53-55 Chalton Street, 60 & 70 Churchway

Basement Impact Assessment
Audit

London Borough of Camden

Project Number: 12985-71

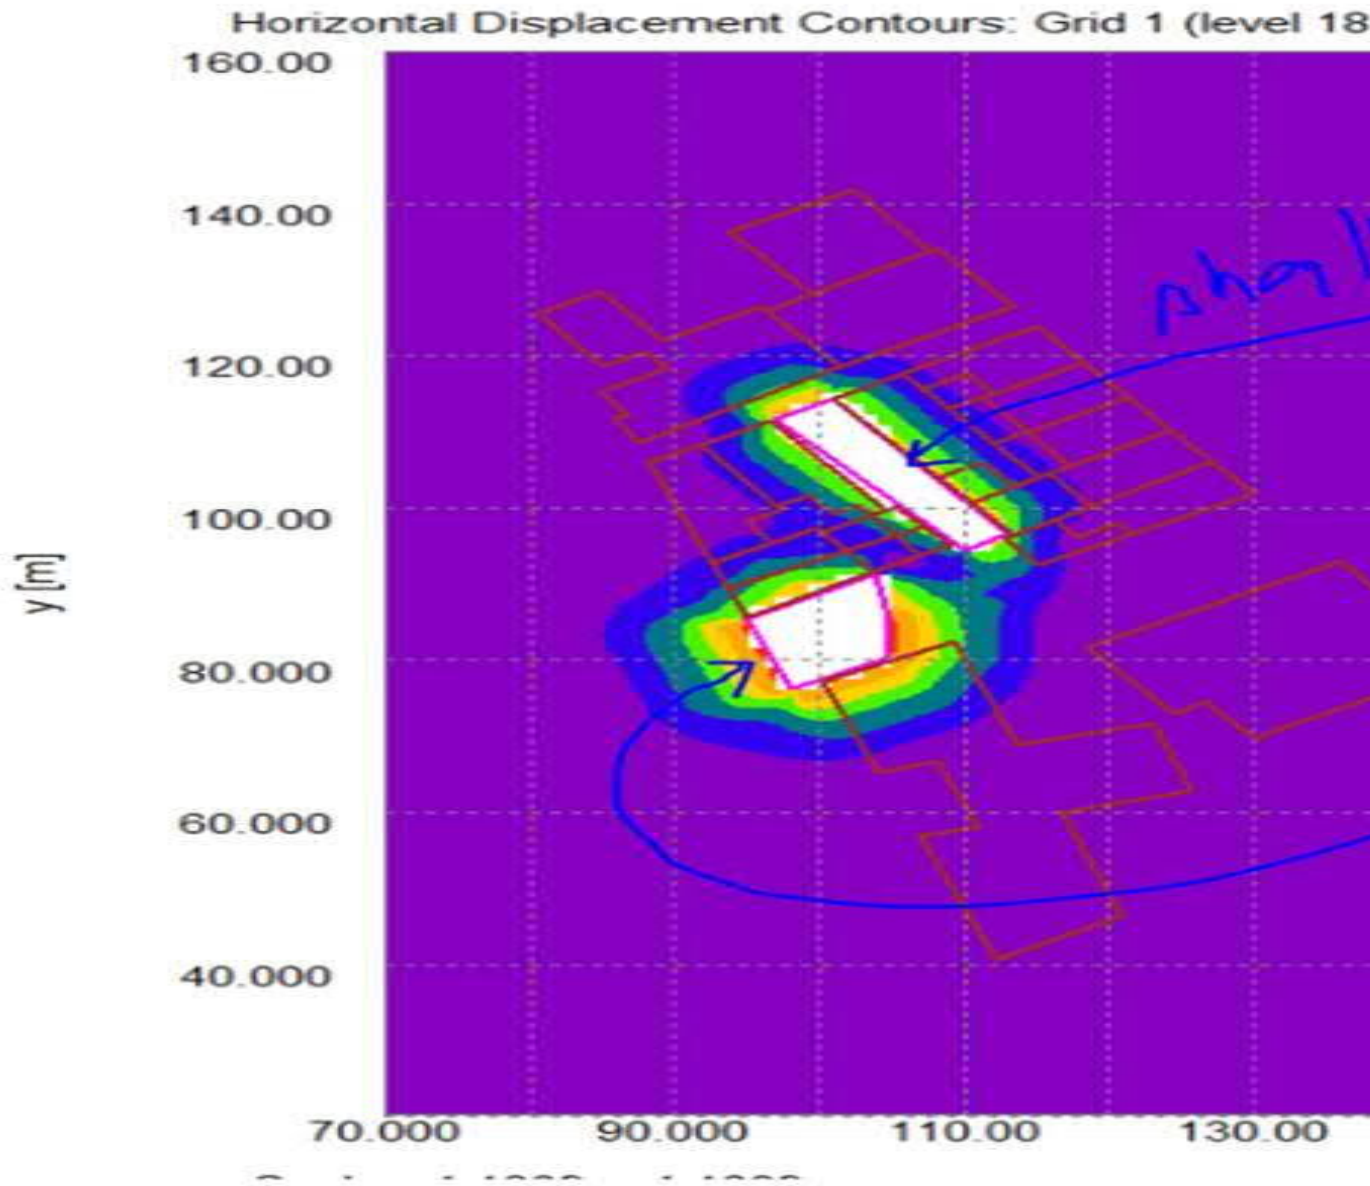
I think there has been some crossover in message. I spoke to the GMA authors (A2 Studio) several weeks ago and explained that we would not accept a limiting horizontal movement of 2mm. This is not a reasonably conservative approach as required by the Terms of Reference. We discussed movements in the of 5mm+ being acceptable as the basis of assessment, assuming this is supported by the proposed temporary /permanent works scheme. We have been expecting a revised submission on that basis.

I clarify the basis of the cat 1 damage predictions in our GMA;

Underpinning installation horizontal movement has been considered as being 2mm

Bulk excavation horizontal movement has been considered as being 4mm

As part of the assessment presented herein, the empirical CIRIA 760 excavation was scaled to 80% which equates to a maximum movement at surface levels of 4mm during the excavation phase. The assessment assumes that the maximum horizontal movements due to the underpinning works in isolation are 2mm towards the site. Adhering to these limits would ensure the robustness of the solution and help to limit the possible damage of the neighbouring properties to Category 1 (Very slight).

The horizontal movement at ground level considered in the damage classification by XDISP is thus 2mm + 4mm + 6mm. The result of this can be seen in the plot below;
